Case: Wood Duck /Geenex Solar 2024-00337

RE: Foreign ownership of solar portfolios and Geenex's role with the EDF

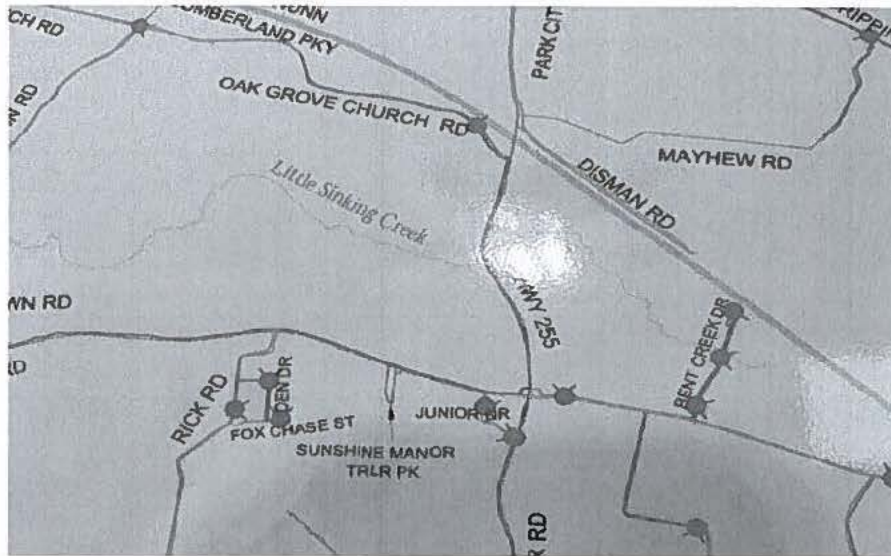
The Stantec study for glare used latitude and longitude while the Stantec study for sound used "sound receptors" which are numbered structures along the roads and the maps do not identify the roads, so one cannot determine addresses. (Example, SR-083) Stantec should combine their systems to allow easy readability by the public.

Stantec needs to use parcels and addresses so one can easily understand the impact of the project and how it will be designed. Waking up to solar panels 83 feet from one's home would be a nightmare.
